# SERVICE BULLETIN

No. 229A

Piper Aircraft Corporation

**SUBJECT:** Removal of Restriction to Airspeed Limits

# SKETCH A

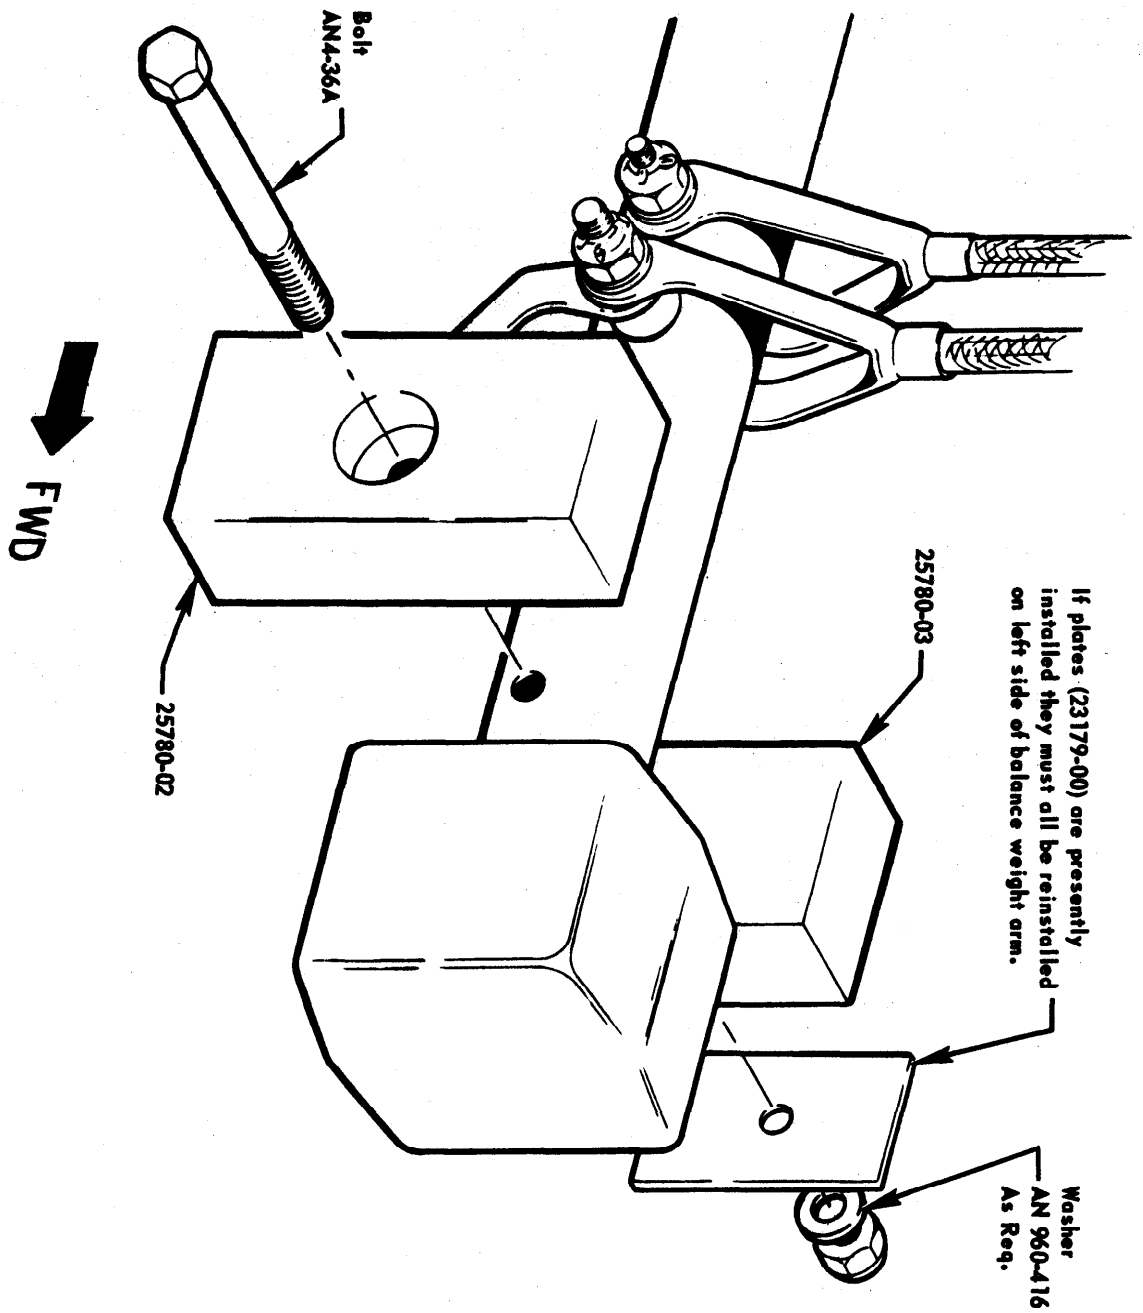
A placard for the airspeed indicator, a revised Flight Manual, Stabilator Balance Weights and an AN4-36A bolt are contained in Kit 757 044. Information concerning the installation of this kit is contained on sketch "A" attached to this bulletin.

If plates (23179-00) are presently installed they must all be reinstalled on left side of balance weight arm.

PLACARD SK1814

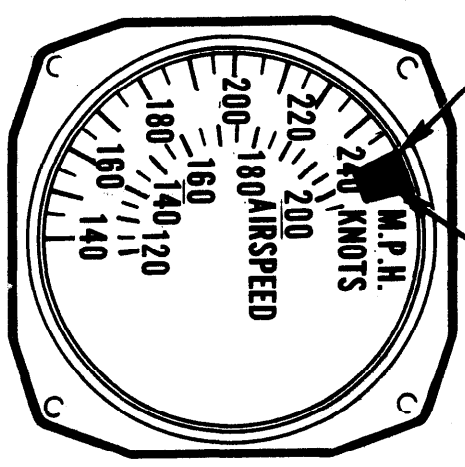
The Airspeed Indicator Placard SK-1814 contained in Kit 757 044 must not be installed on aircraft equipped with Brittain Industries Tip Tanks model No. TT-5 since these aircraft are restricted to a 230 MPH never-to-exceed speed limit. However, the balance of the requirements contained in this bulletin remain effective.

LOCATE THIS EDGE OF PLACARD AT 240 M.P.H.

# SKETCH B

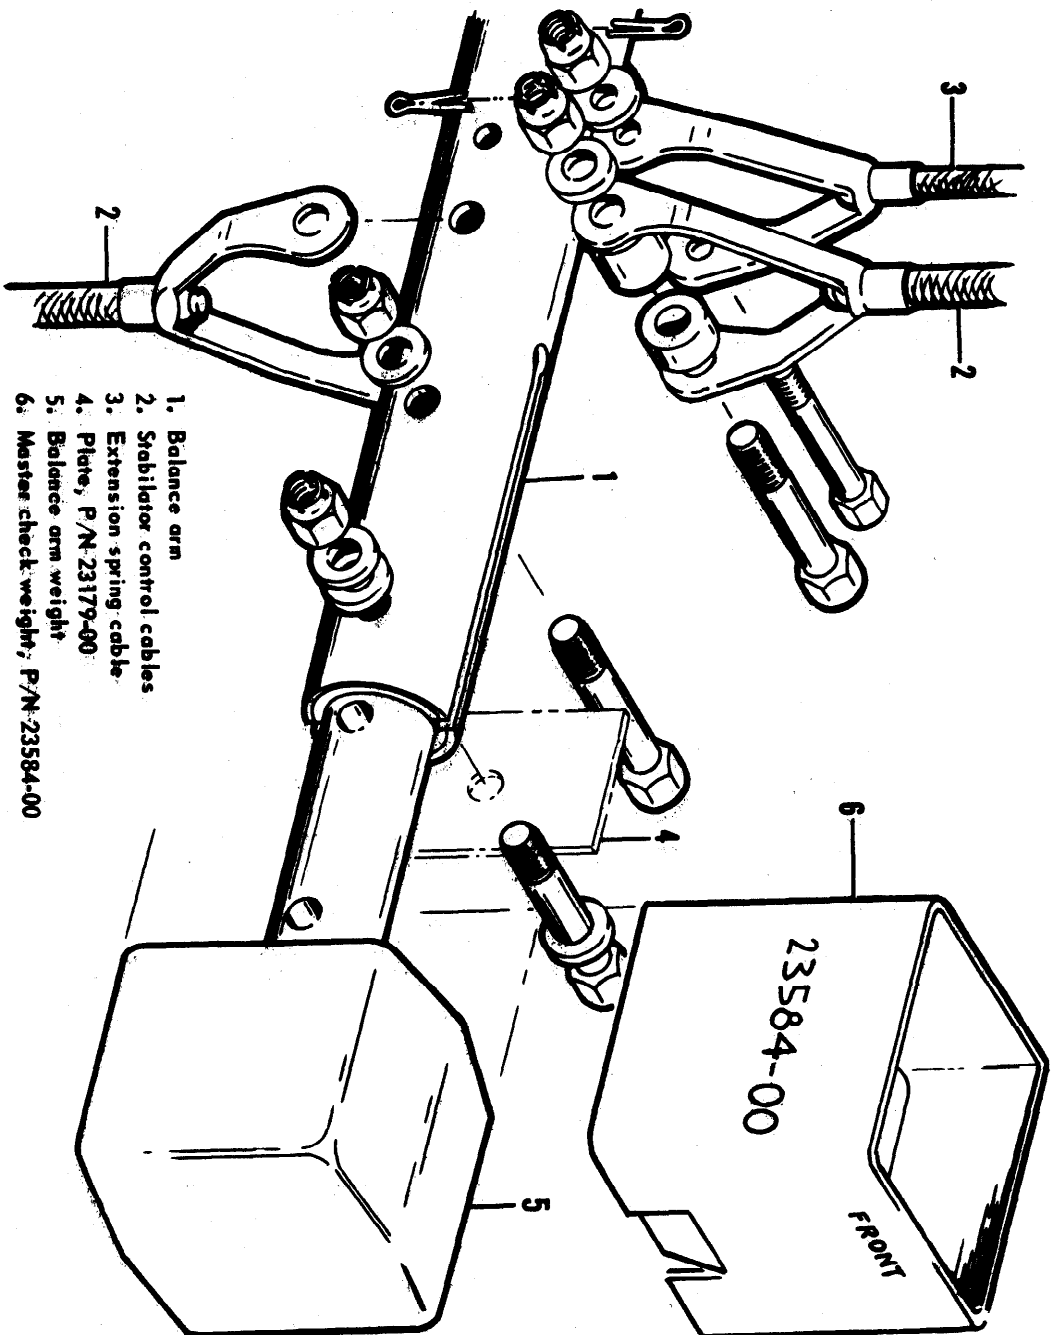
c. Master check weight 23584-00 (weight 1.58 pounds) should be placed on top of balance weight 23594-00 with the side marked "FRONT" facing forward. If this is not enough weight to obtain static balance with the balance arm level, plates 23179-00 must be added to the forward balance weight attachment bolt until 100% static balance is obtained or until up to two plates more than that required for balance have been added. It should never be necessary to use more than eight plates. If a total of more than eight plates are necessary to obtain balance, the manufacturer should be consulted.

e. After balancing is accomplished, the check weight should be removed and the front attachment bolt connecting the stabilator balance weight to the stabilator balance arm shall be removed and weights, part nos. 25780-02, 25780-03 and bolt AN4-36A and stabilator balance weight plates 23179-00 shall be installed at this attachment point. Stabilator balance weight, part no. 25780-02 shall be installed on the right side of the stabilator balance arm and stabilator balance weight, part no. 25780-03 and stabilator balance weight plates 23179-00 shall be installed on the left side of the stabilator balance arm.

Balance weight, part no. 25780-02 shall be installed such that the counter-bore and bolt head face outboard on the right side of the balance arm.
